Inter-Office Memorandum  
Review & Comment

Date: August 15, 1979  
TSG-362

Subject: Guidance on Turbine Bypass Valve Operation

Reference: Control of Natural Circulation Using the Turbine Bypass Valves,  
J. P. Moore to R. C. Arnold, TSG-333, dated August 6, 1979

Figure 4

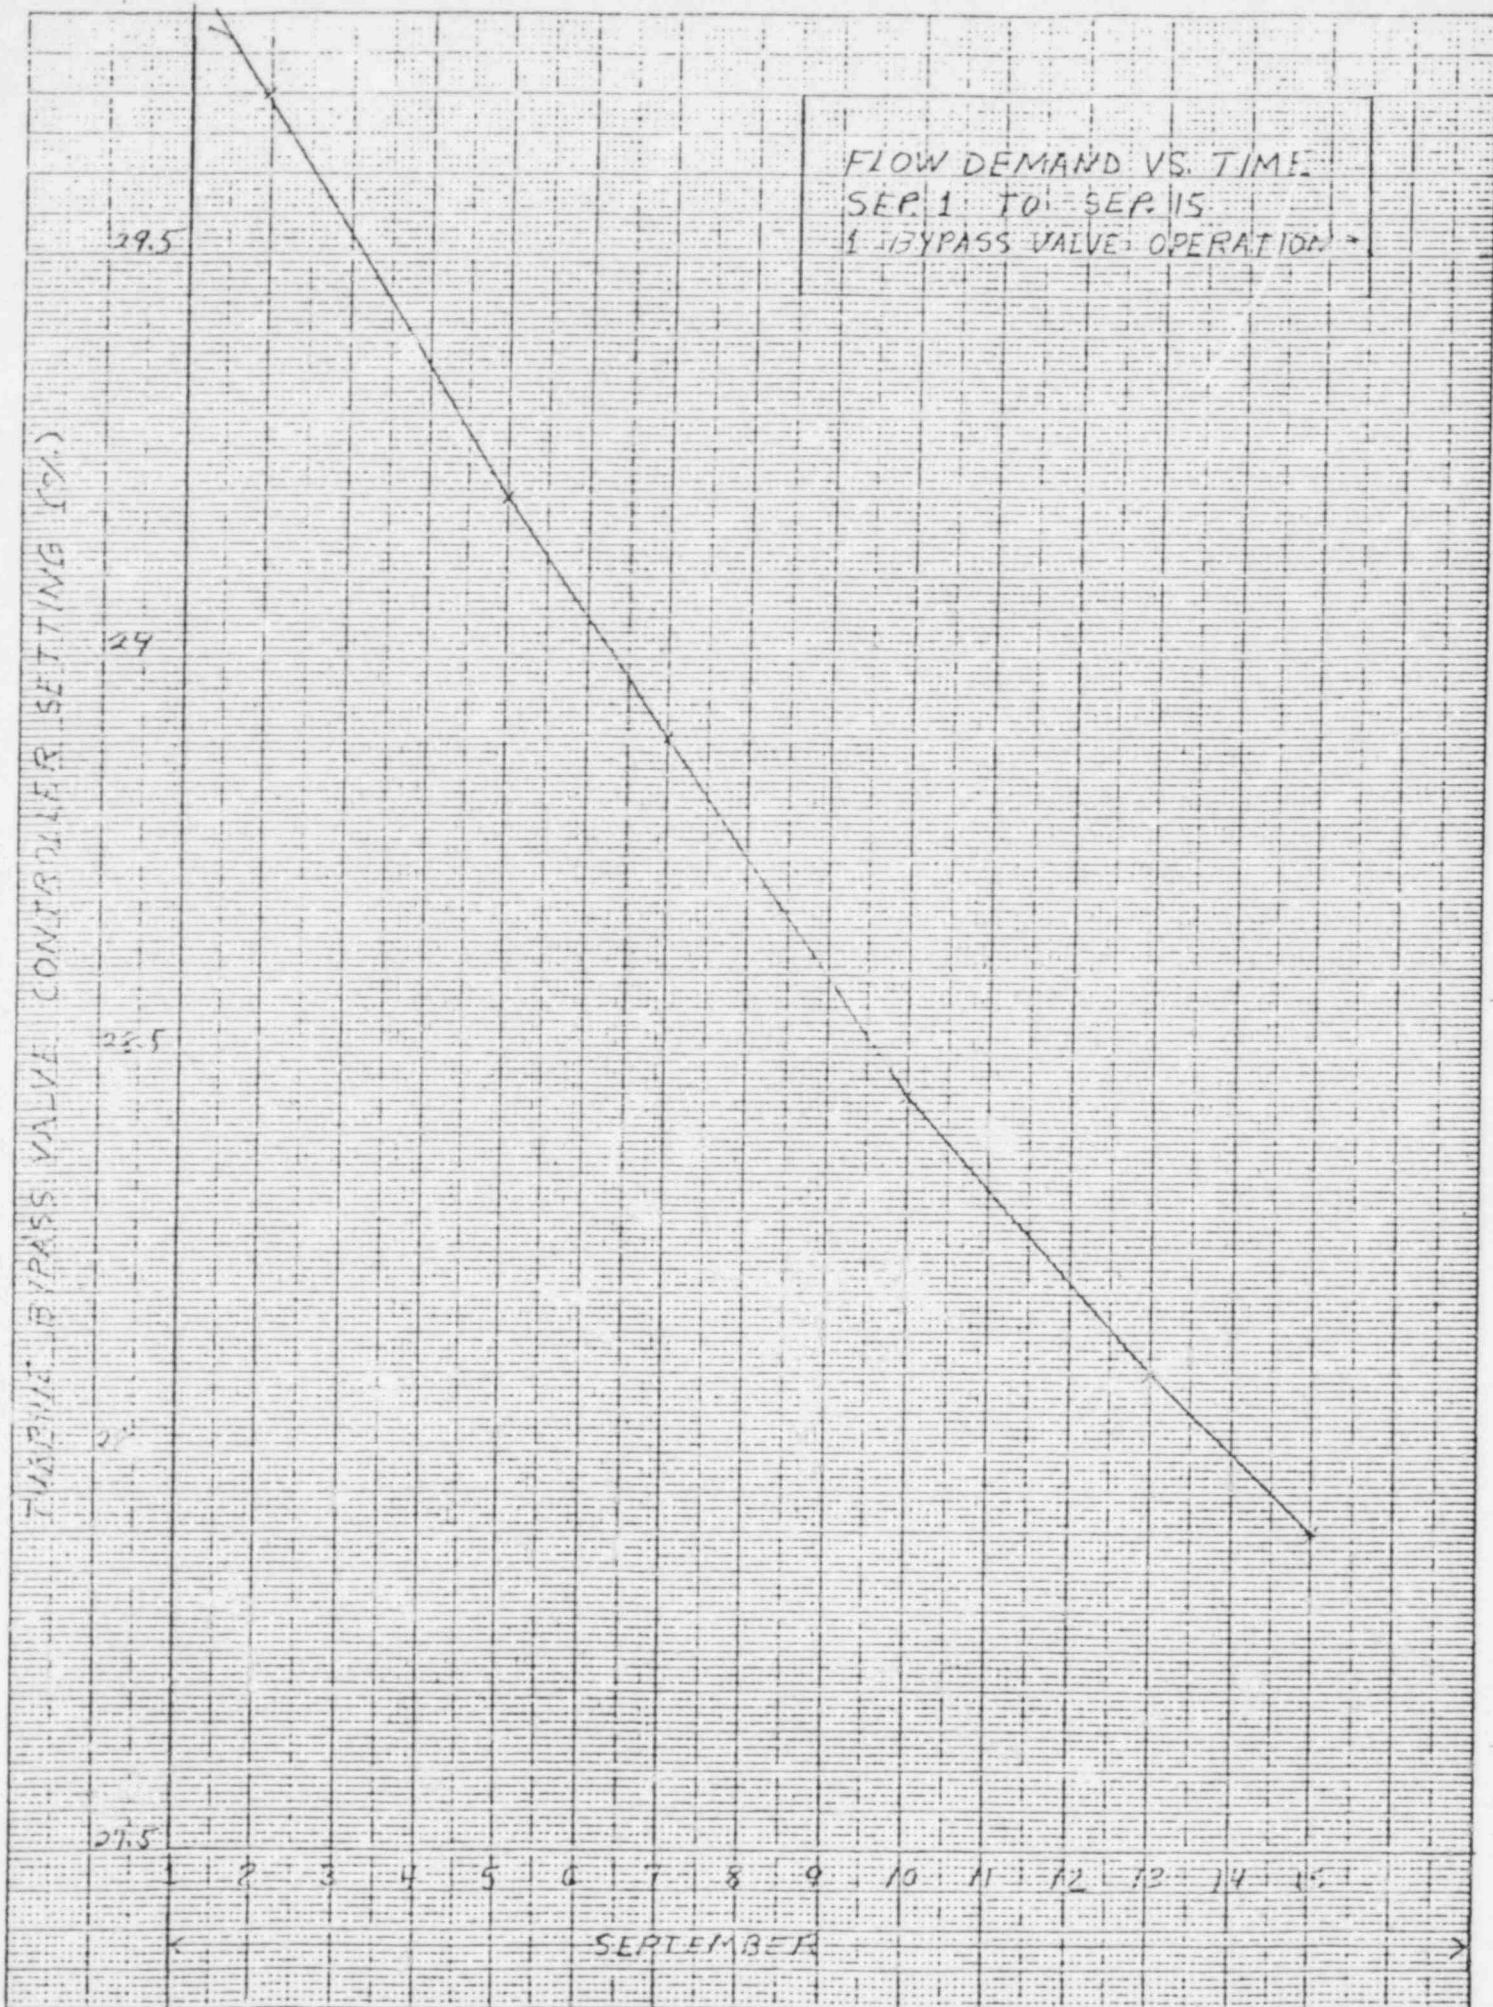
Attached are revised copies of the curves included with the reference. These curves have been biased by the difference between the calculated position and the actual position obtained after the transition had reached equilibrium. Use of these curves and the additional guidance provided above is recommended for turbine bypass valve operation.
